HISTORIC PRESERVATION COMMISSION

SUBJECT: Area Work Permit #1068189 - Roof replacement, chimney

restoration, storm windows, skylights replacement, and roof vent

Address: 7300 Baltimore Ave., Takoma Park

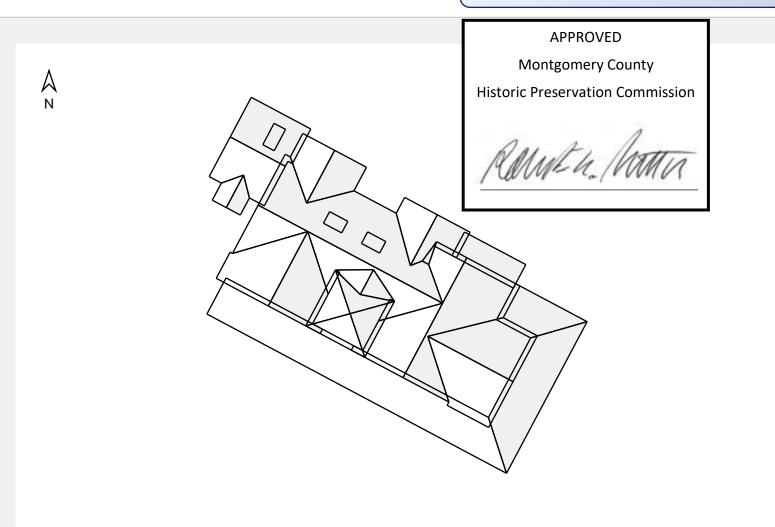
- Please provide specifications for the Velux skylights.
- Please indicate the location of the 4 skylights to be replaced. You could either mark them on a roof plan or aerial or mark them in photos.
- What size are the existing bricks? What will be the size of the replacements?
- Please provide a representative photo of the proposed replacement brick.
- The current ridge vent is metal. What will be the material of the replacement ridge vent?

- Please indicate the location of the 4 skylights to be replaced. You could either mark them on a roof plan or aerial or mark them in photos.
 Please see attached photos and attached roof sketch
- What size are the existing bricks? What will be the size of the replacements? We are only working on the roof.
- Please provide a representative photo of the proposed replacement brick.
